NL-21-0019

Joseph M. Farley Nuclear Plant – Units 1 and 2
Response to Request for Additional Information Regarding Application to Adopt 10 CFR
50.69, "Risk-informed categorization and treatment of structures, systems and
components for nuclear power reactors"

SNC Response to NRC RAI

Figure 1-2
Relationship With the 10 CFR 50.69 Rule and Other Guidance Documents

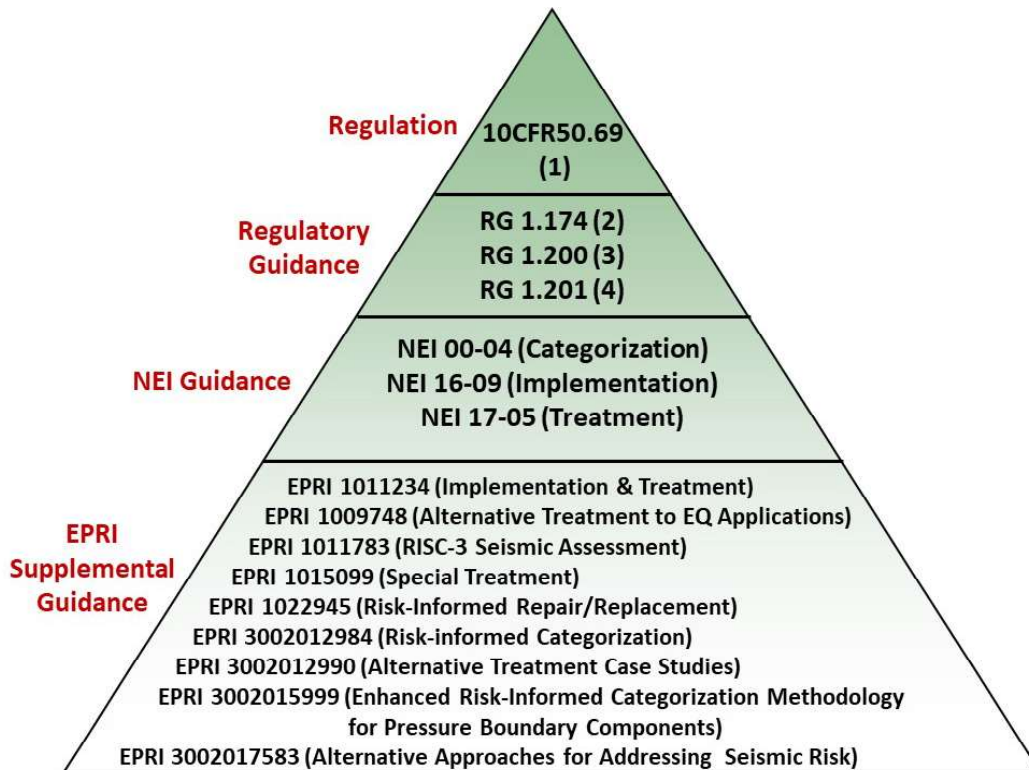
1. Figure 1-2 was edited to include EPRI 3002017583 in the list of §50.69 supplemental guidance documents.
 2. Figure 2-2, Low Seismic Hazard Site: Typical SSE to GMRS Comparison – replaced graph with correct graph.
- (c) EPRI 3002017583 has incorporated all the information and follow up actions from the CCNPP LAR supplements that was agreed upon by the NRC staff's review of the alternative seismic approach for Tier -1 plants. Therefore, Attachment 2 of ML19200A216 are applicable to Farley since it is using the updated EPRI Document 3002017583, Alternative Approaches for Addressing Seismic Risk in 10CFR 50.69 Risk-Informed Categorization. Farley's applicability to other CCNPP LAR supplements and attachments are addressed below:
